PRODUCT CHANGE NOTIFICATION

PCN-DC-Z228-12

Business Unit	Product Line Code	Type of Change	Action	Date of issue
DC	AAC	Mechanical	Notify Distributors and Field	10/2/2012

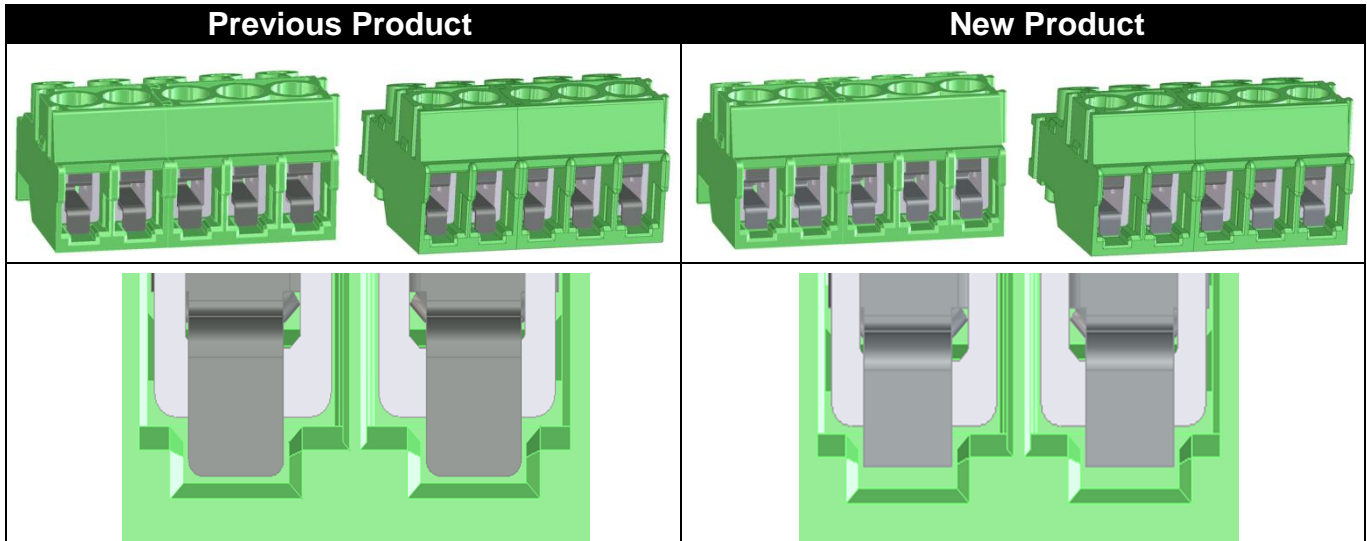
Due to our continuous improvement process the above mentioned parts will be delivered with a shorter tongue of the current bar on the front side of the plugs as shown on the pictures. The tongue of the current bar will also get sharp corners. Dimensions and technical data will remain the same. During the conversion period both versions will be delivered depending on inventory.
